BTB 51970-01293 REV3 (1412)

Recall: Driver's Airbag Inflator May Produce Excessive Pressure After Long-Term Exposure to High Absolute Humidity

Supersedes 14-029, dated September 26, 2014; to revise the information highlighted in **yellow**

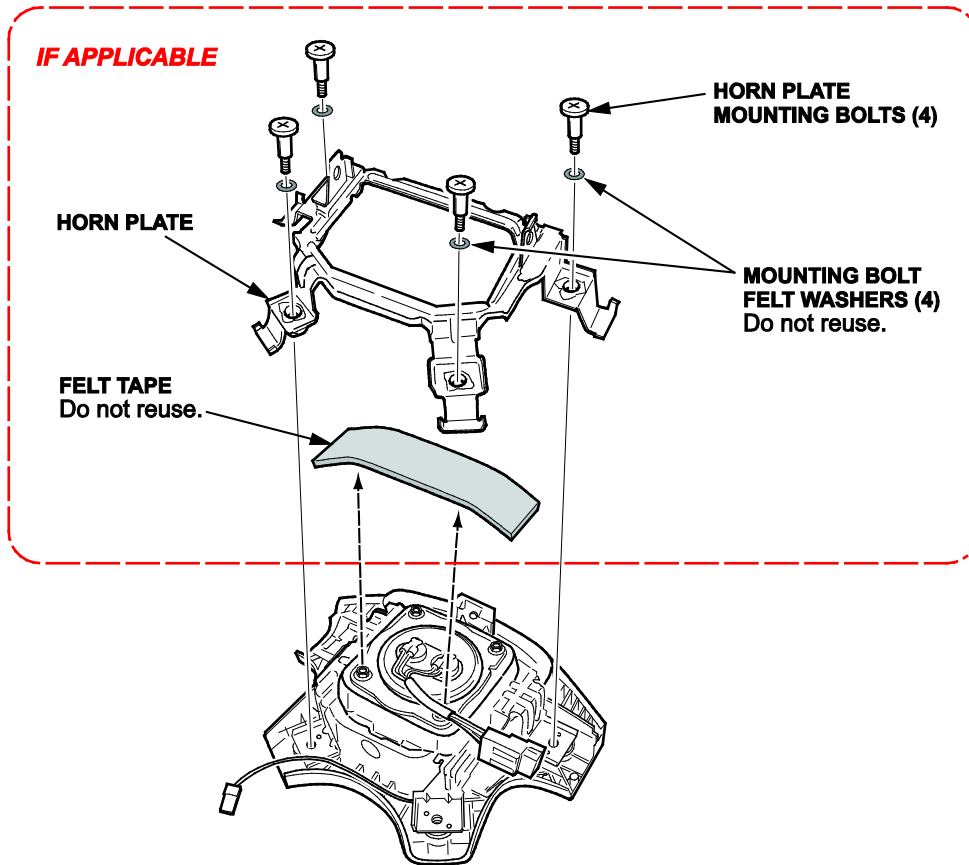
3. Place the airbag, face down, on a clean shop towel.
4. Visually inspect the airbag and the inflator for any unusual writing or markings.
 - If there is nothing unusual about the airbag or the inflator, go to step 5.
 - If there are any unusual markings, like an incorrect label or a model year written in marker, the airbag and inflator may not be the correct airbag and/or inflator for the vehicle or it may be a counterfeit part. For more information about counterfeit airbags, you can refer to safercar.gov, enter keywords **MANAGING COUNTERFEIT**, and select **Recommended Dealer Guidance for Managing Counterfeit Air Bags** from the list. **If you suspect that the airbag or inflator is counterfeit, do not continue this procedure.** Contact your DPSM for assistance.

NON-STANDARD
SAFETY LABEL

NON-STANDARD
WIRES

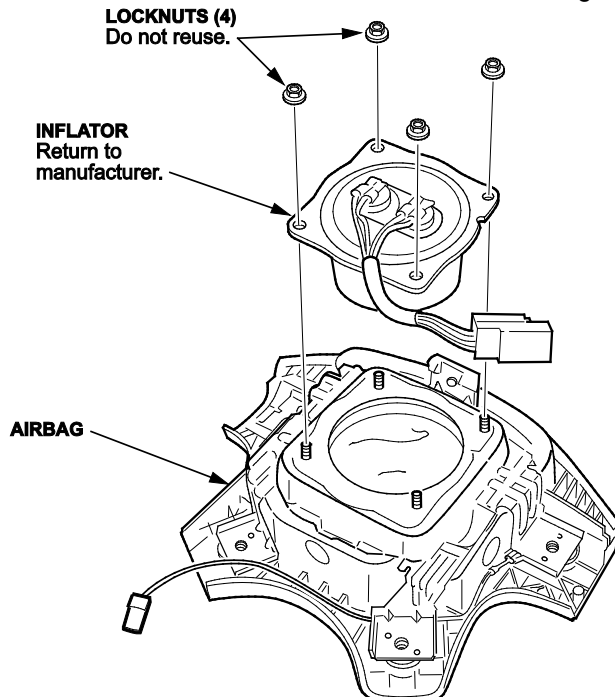
5. If there is no horn plate installed, go to step 7. If there is a horn plate installed, remove the four horn plate mounting bolts, the mounting bolt felt washers, the horn plate, and remove the felt tape covering the lower two inflator locknuts. The felt washers and felt tape will not be reused.

6. Using needle-nose vise grips or a 3/8 in. 6-point socket, remove the four locknuts from the inflator. The locknuts will not be reused.

9. Install the new inflator in the airbag with new locknuts. Torque the locknuts to **3.9 N·m (2.8 lb-ft, 34 lb-in)**.
